**Town of Hilton Head Island
Regular Design Review Board Meeting
Tuesday, January 23, 2018 – 1:15 p.m.
Benjamin M. Racusin Council Chambers
AGENDA**

Town of Hilton Head Island
Minutes of the Design Review Board Meeting
January 9, 2018 at 12:00 p.m.
Benjamin M. Racusin Council Chambers

North Elevation
N.T.S.

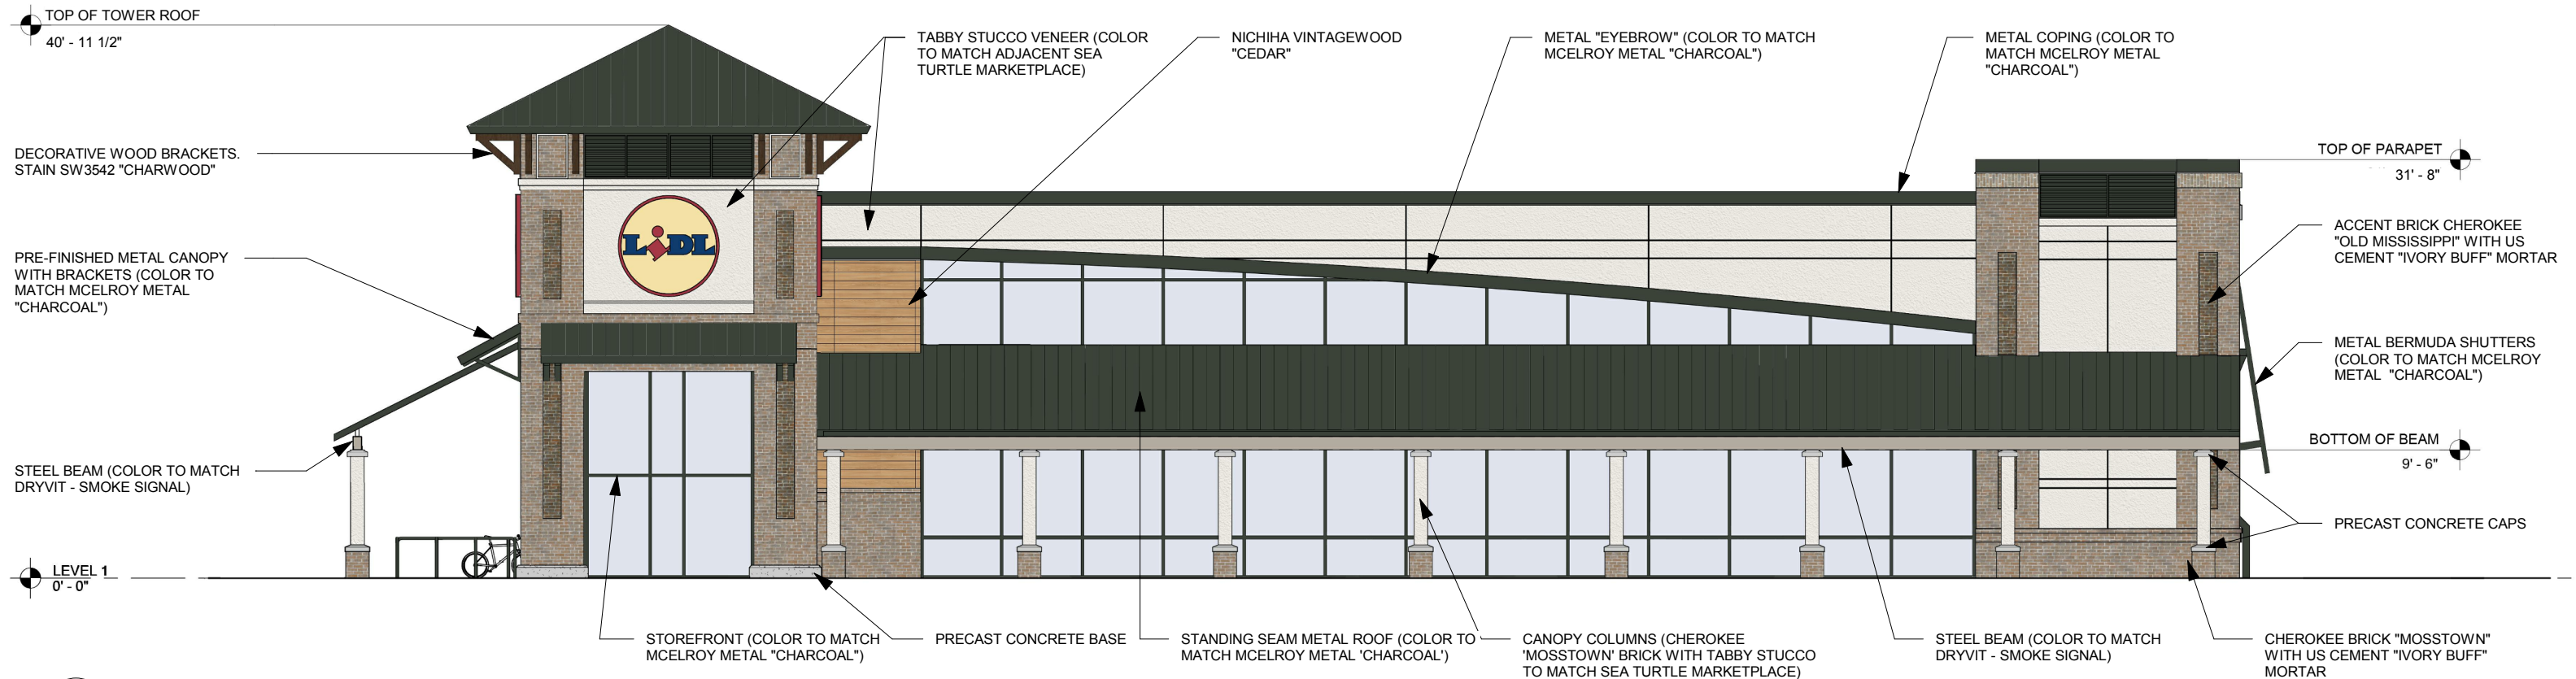
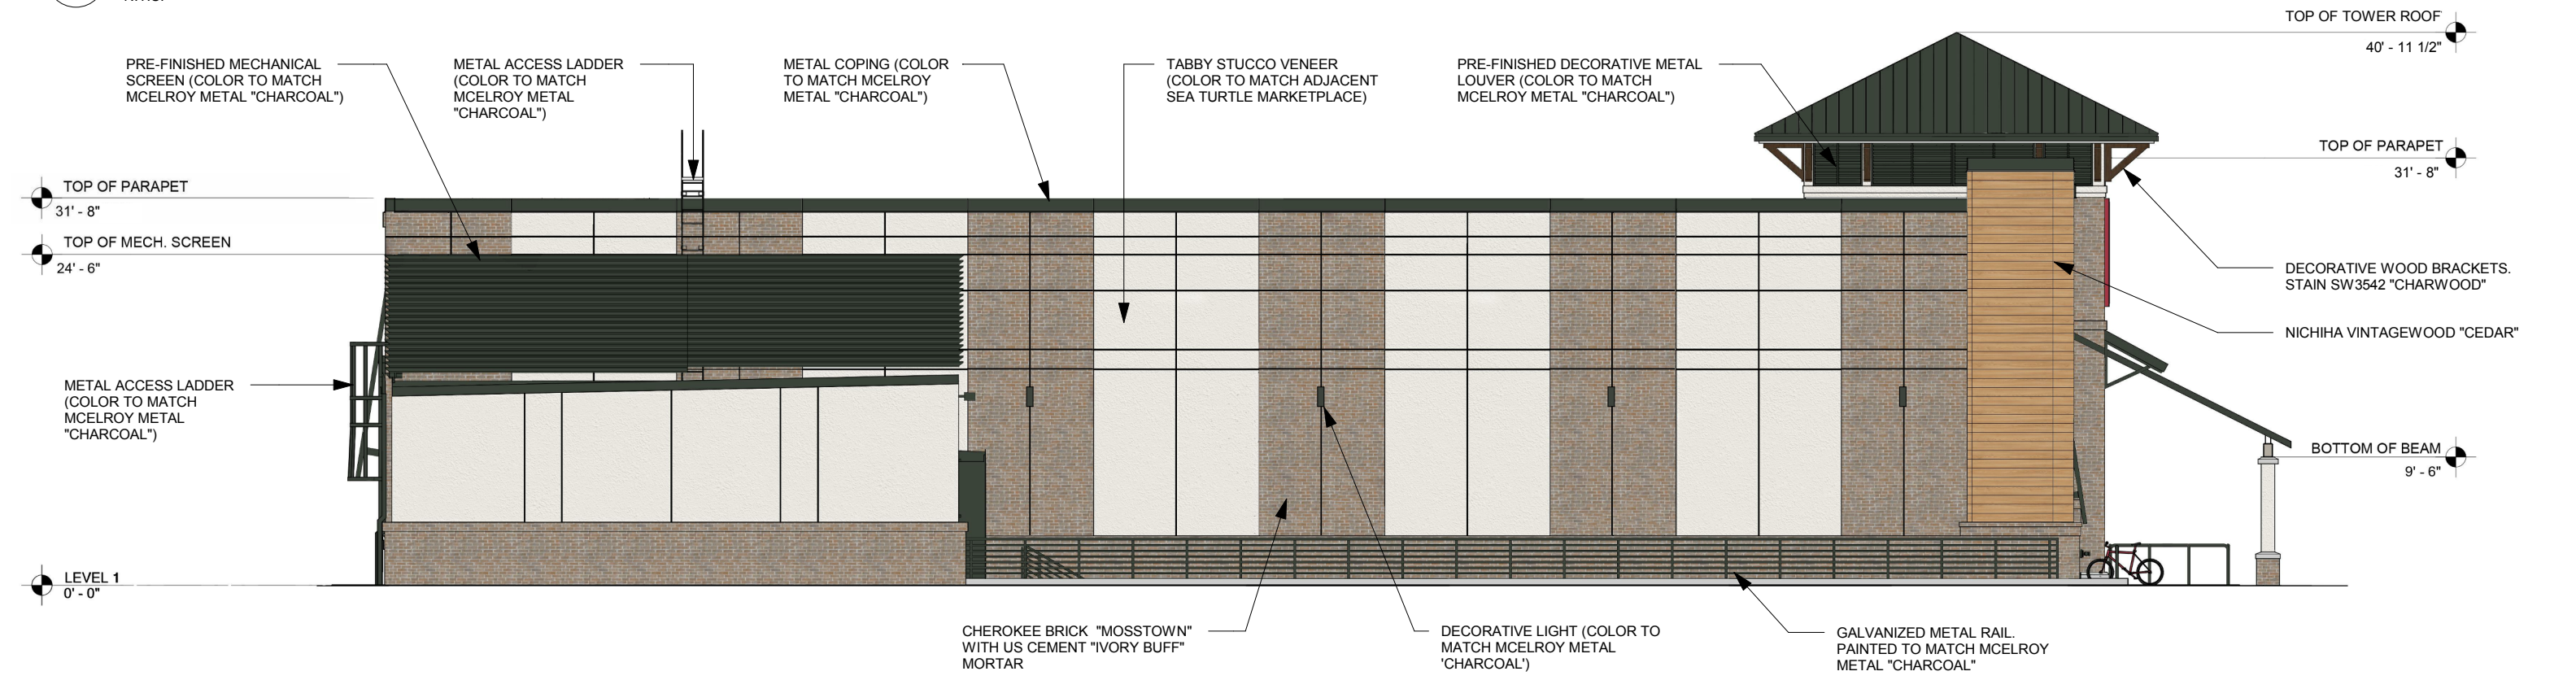
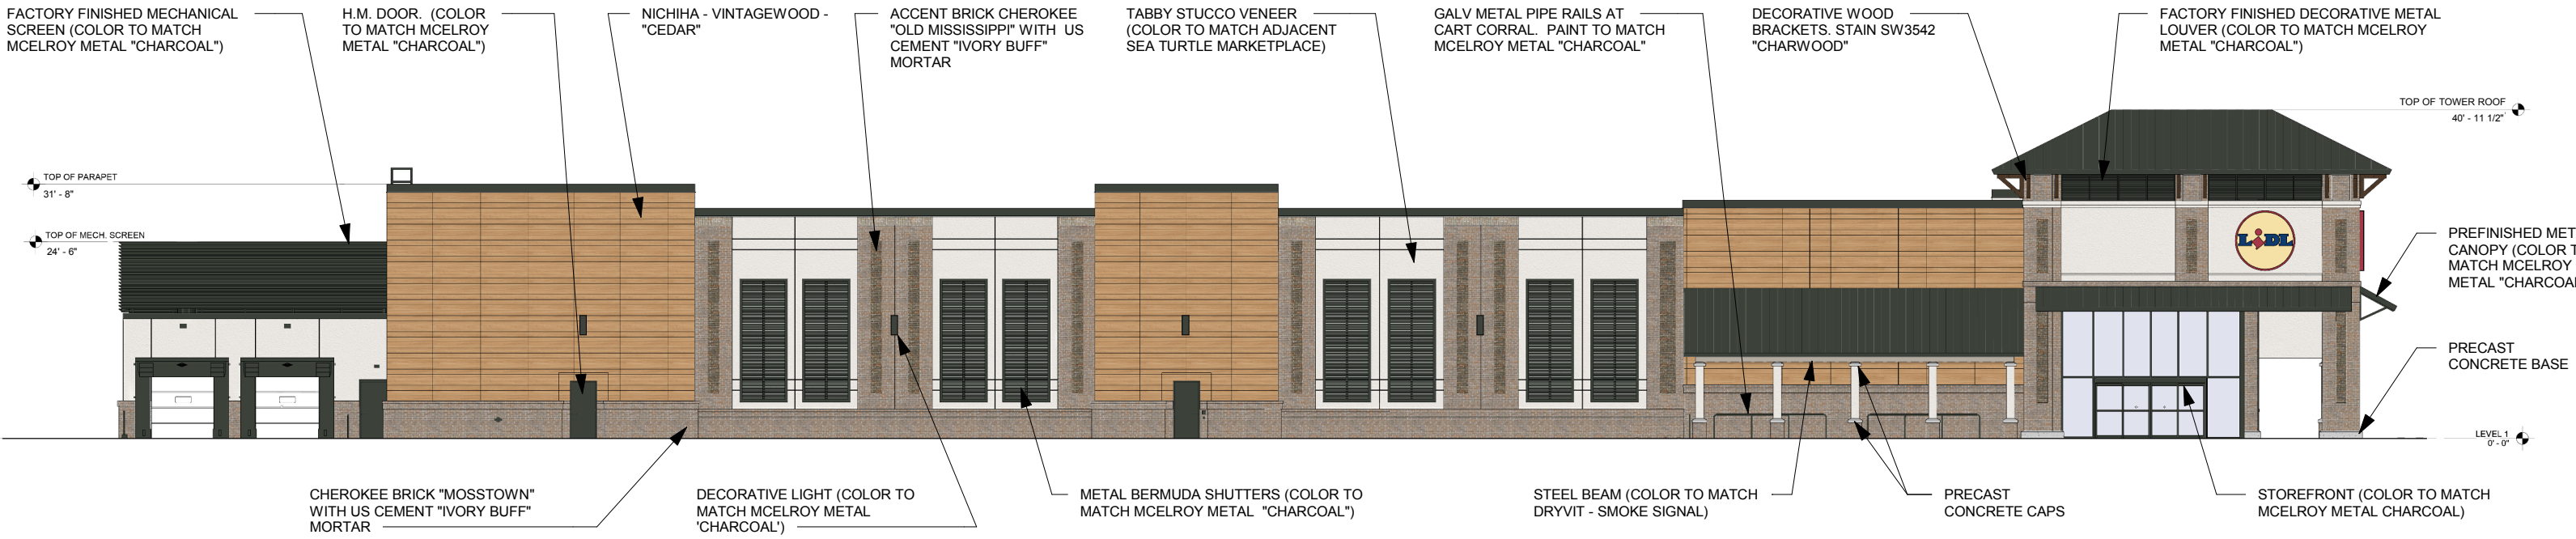
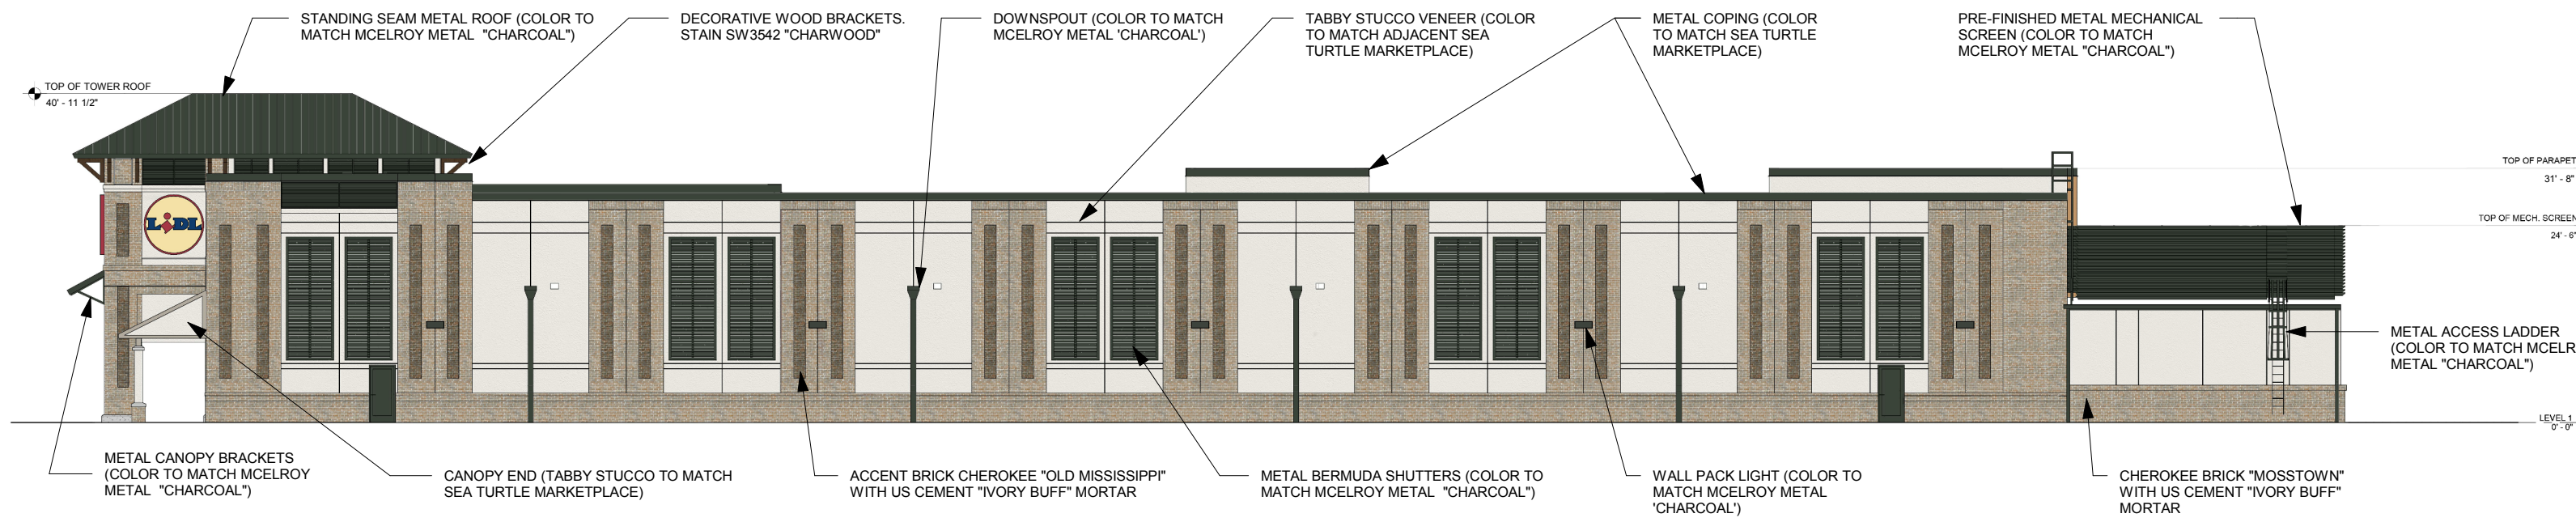
- Address flatness on Matthew Drive elevation.
 - Parapet wall has varied height and wall fenestration is varied in depth.
- Provide roof plan.
 - This has been included.

- Pitch canopy along front of store
 - The roof is now pitched.
- Provide color elevations.
 - Color elevations have been provided.
- Provide details for brackets on roof canopies, louvers, door cut sheets for building doors and loading dock doors, column details, wall sections, and reflected ceiling plan (for exterior ceilings under canopies? I believe anything people will walk under).

SHEET TITLE:
SITE PLAN

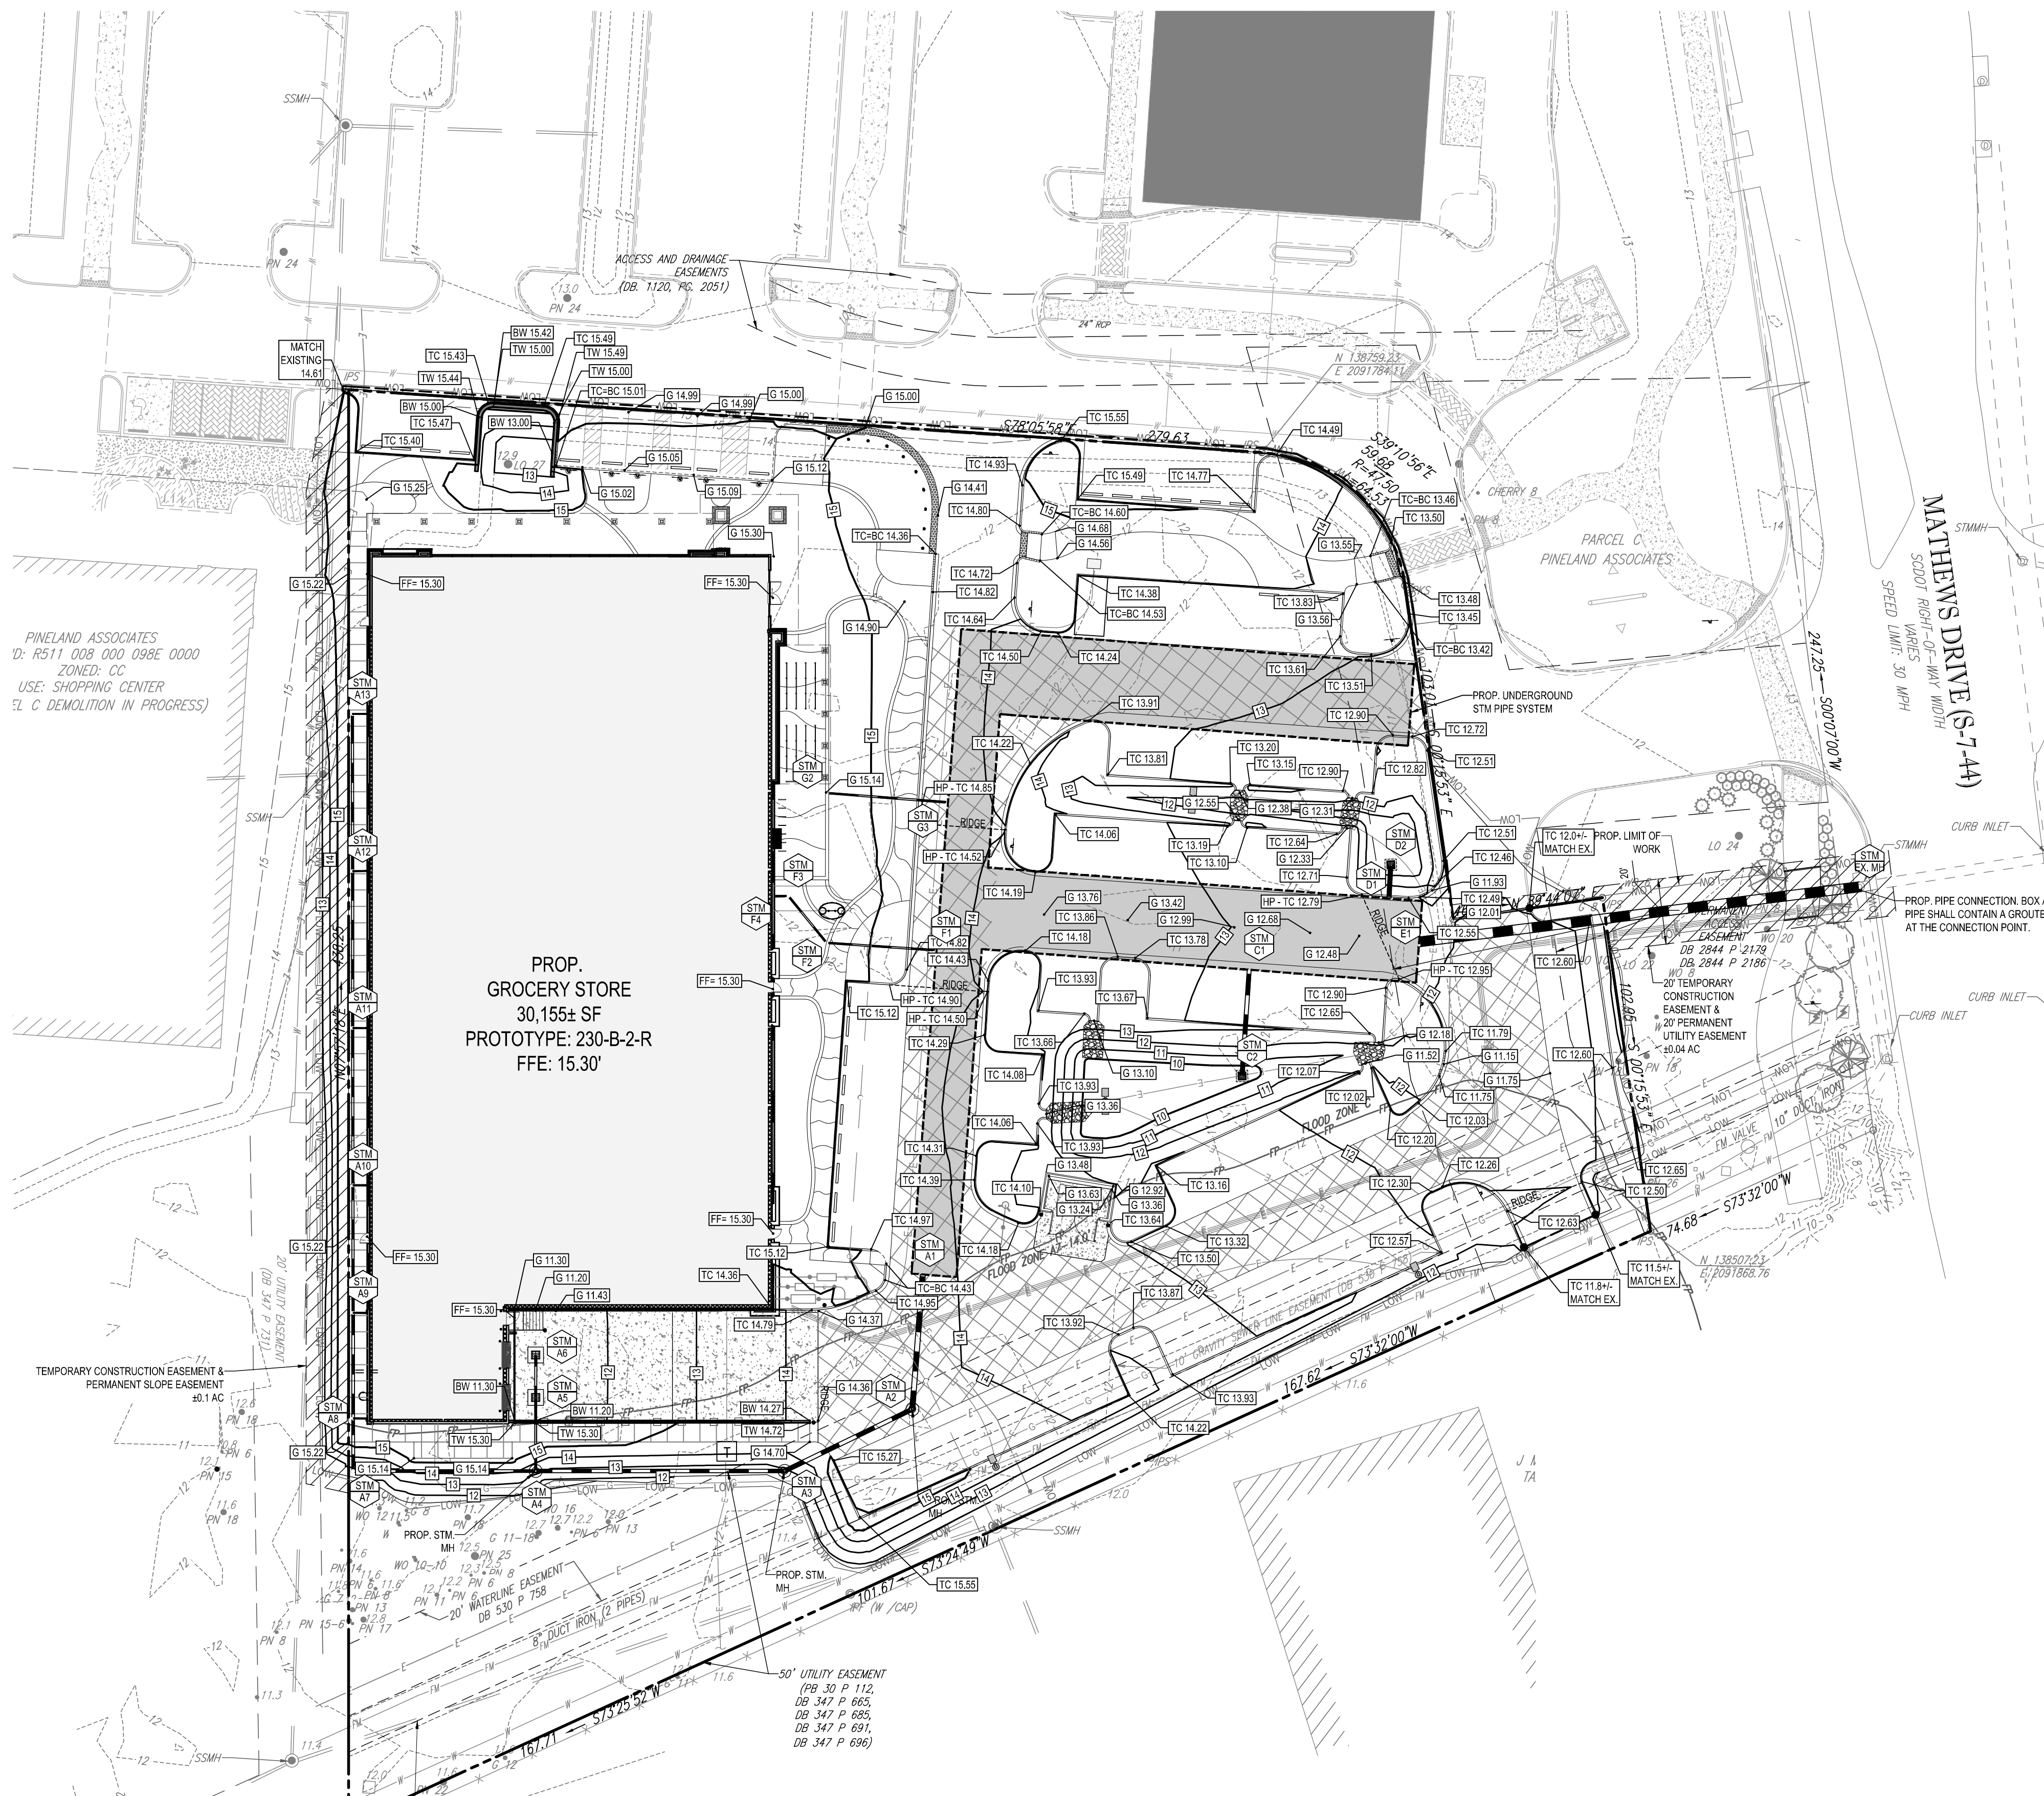
- 11. Revise the site plans to save existing trees.
 - Existing live oak along William Hilton Parkway has been preserved. Design team will coordinate with the town to ensure the tree is properly fertilized and protected during construction.

- 2. Revise the Site Plan to preserve the 27" Live Oak in front of the Hwy 278 elevation.
 - Existing live oak along William Hilton Parkway has been preserved. Design team will coordinate with the town to ensure the tree is properly fertilized and protected during construction.
